PLANNING APPLICATION NUMBER: P/11/0465/PPP

DEVELOPMENT: Rumah, Shieldhill Road, Reddingmuirhead, Falkirk, FK2 0DU

PROPOSAL: Sub-Division of Plot and Erection of New Dwellinghouse

Subject: P-11-0465-PPP Shieldhill Road

Visibility east at proposed access 30m back from private road

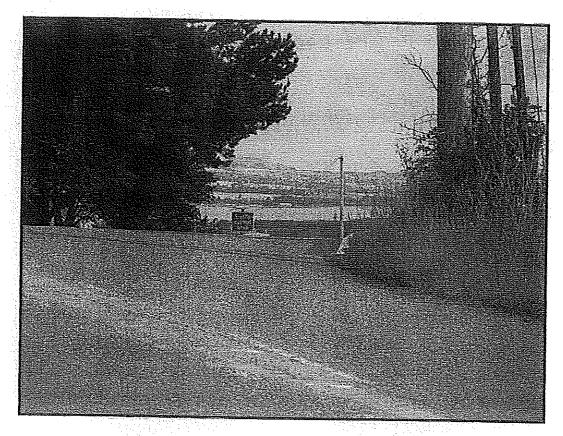
The supporting statement states, that from the proposed access to the site east along Shieldhill Road, a visibility splay of 2.5m x 76m is achievable. This is not the case. For any avoidance of doubt we measured the visibility from the proposed site yet again, and to try and make things completely clear, recorded the results with photographs (see attachment 1). The supporting statement also states that a visibility splay should take the curvature of a road in to account. Again this is wrong. A visibility splay is taken from the proposed access to the furthest point on the nearer edge of the major road carriageway channel that one can see (see attachment 2). The 'y' measurement in this case was found to be 47.7m. We also went on to show photos of the view of our operative with staff at 78m at the south channel of the road as shown on the applicants drawing (see attachment 3), then at 70m and then 60m (the operative is only in view at 60m as she moved a metre or so out from the road channel). The visibility splay as shown by the applicant is taken to the wrong side of the road and the actual visibility claimed cannot be achieved on site.
